# UNITED STATES PATENT AND TRADEMARK OFFICE

10/579,770

<b>Office Action Summary</b>	<b>Application No.</b>	<b>Applicant(s)</b>	
	10/579,770	KAERN ET AL.	
	<b>Examiner</b>	<b>Art Unit</b>	
	ILYA Y. TREYGER	3761

### **DETAILED ACTION**

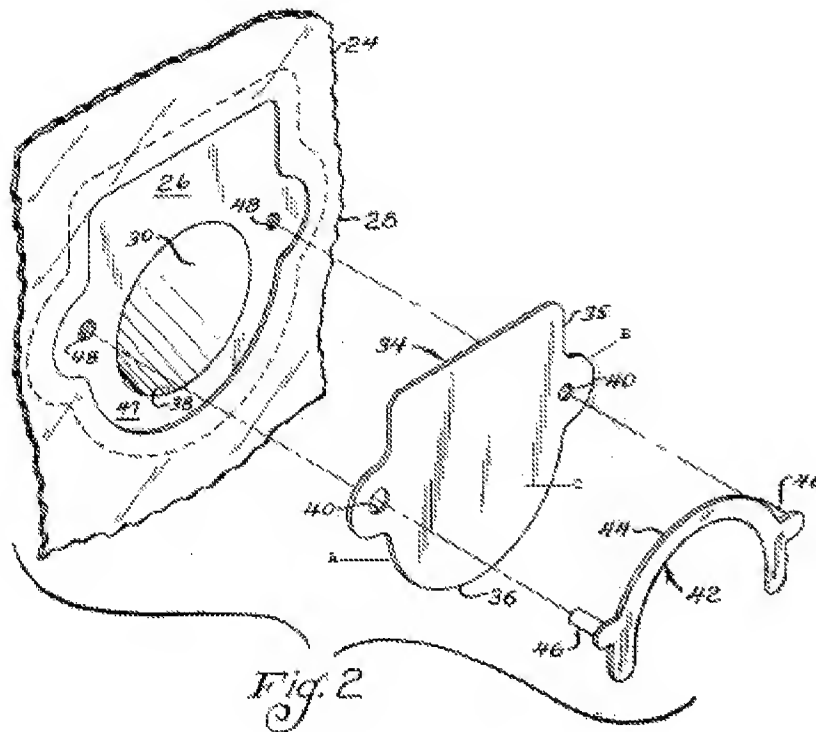
7. In Re claim 1, Boedecker discloses an anti-reflux device (Abstract, line 1) comprising: a wall 28 (Fig. 2) providing a drip chamber 26 (Fig. 2) which is a valve seat, and a valve element 34 (Fig. 2) defining an outer contour A (Fig. 2) formed from a sheet-shaped material, said valve element including a connection portion B (Fig. 2) and a flap portion C (Fig. 2) defining a longitudinal direction extending between the connecting portion and the flap portion, and bores 48 (Fig. 2) which are retaining means for retaining the valve element 34 with respect to the device, said retaining means being integral with the device. The connecting portion B includes apertures 40 (Fig. 2) which are engagement means formed integrally with the valve element for engagement with the retaining means, wherein the valve element is projecting a coherent plane (See Col. 2, lines 46-51, 64; Col. 3, lines 7-13).

9. In Re claims 6, 7, and 9, Boedecker discloses a device in which said outer contour A forms a curve defining a continuously advancing function on a respective side of the longitudinal direction (claim 6), and wherein the engagement means 40 are formed within (claim 7) and integrally (claim 9) in said outer contour (claim 7) (See Fig. 2).

In Re claim 12, Boedecker discloses the valve element 34 (Fig. 2) including at least one connecting portion B (Fig. 2) and a flap portion C (Fig. 2) and defining a longitudinal direction

extending between the connecting portion and the flap portion, and with engagement means 40 (Fig. 2) integrally formed in the valve element (Col. 2, lines 46-51, 64; Col. 3, lines 7-13).

Fig.

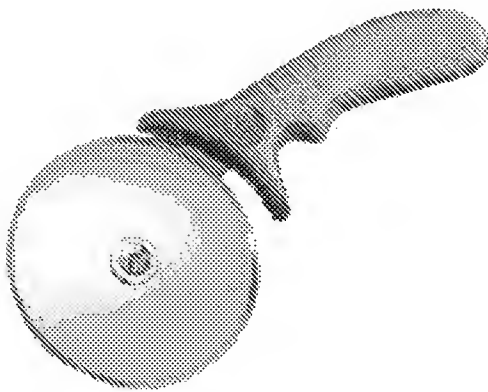
15. In Re claim 18, Boedecker discloses the claimed invention except for the method in which the cutting operation is performed in a rolling operation. It would have been obvious to one having ordinary skill in the art at the time the invention was made to perform the cutting operation in the rolling operation. Examiner takes an Official Notice that the the rolling operation has been conventionally used in the cutting process (See Fig.).

**FIG.2**

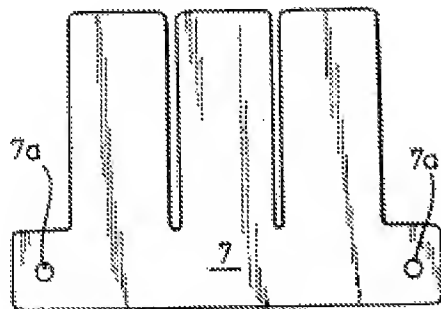
Boedecker discloses the claimed invention discussed above, but does not expressly disclose the device, wherein the engagement means are slit-shaped (claim 8) or incision-shaped (claims 3 and 4).

Morone teaches the flap valve wherein the valve element is slit- or incision-shaped (since the incision is a variation of slit) (See Fig. 2).

It would have been obvious to one having ordinary skill in the art at the time the invention was made to make the valve element of Boedecker slit- or incision-shaped, as taught by Morone in order to improve valve element fixation.
